MIL-I-83456(USAF)
AMENDMENT 2
2 June 1976

INSTALLATION OF SEGMENTED LIGHTNING DIVERTER STRIPS ON
AIRCRAFT RADOMES, GENERAL SPECIFICATION FOR

This amendment forms a part of Military Specification
MIL-I-83456(USAF), dated 20 December 1974, and is
approved for use by all Departments and Agencies of
the Department of Defense.

FIGURE 2. Current test waveform components for evaluation of direct effects.

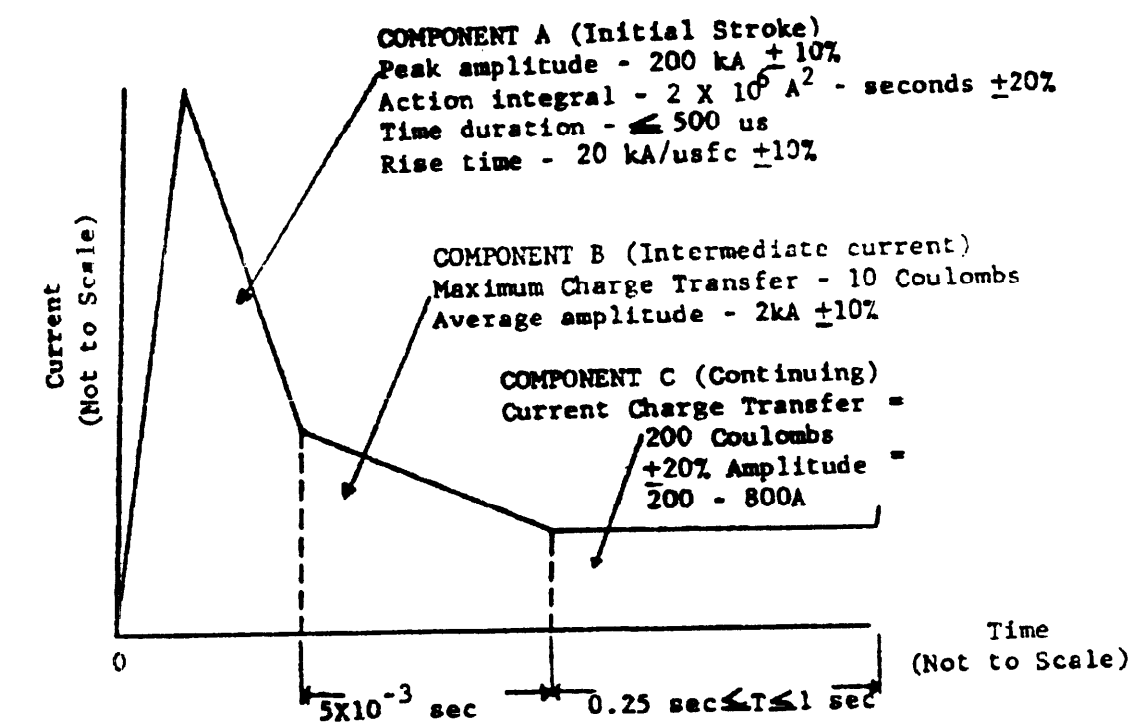
Appendix B, paragraph 20, Delete and substitute:

"Tests of radomes require application of multiple waveform
components I-A and I-B in one discharge and of waveform I-C

in a separate discharge, see figure 2. The level of charge transfer (I-C) for nose radomes and other radomes in Zone IA** area shall be determined for each individual weapon system and radomes from the equation

For radomes in Zone IB*** area the levels specified in figure 2 shall apply."

FIGURE 3. Fast rate of change current waveforms for evaluation of indirect effects.

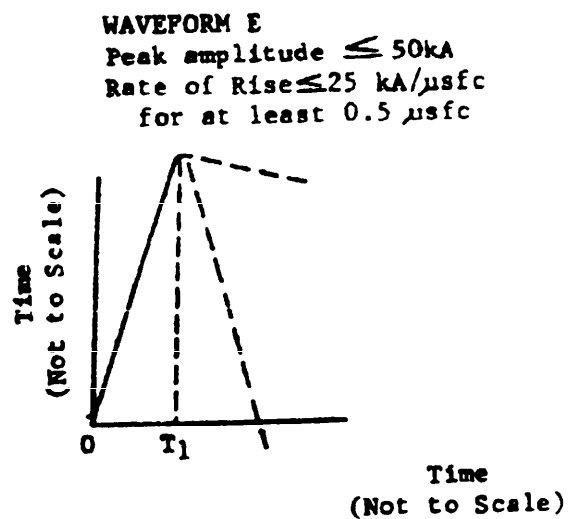
"To measure the indirect effects of lightning, the waveform and specifications of figure 3 shall be used. The current risetime shall be the maximum available from the generator. The results of the measurement shall be extrapolated linearly to the 200 KA peak, 100 KA per microsecond risetime levels."

Add figure 3. Figure 3 forms page 4 of this amendment.
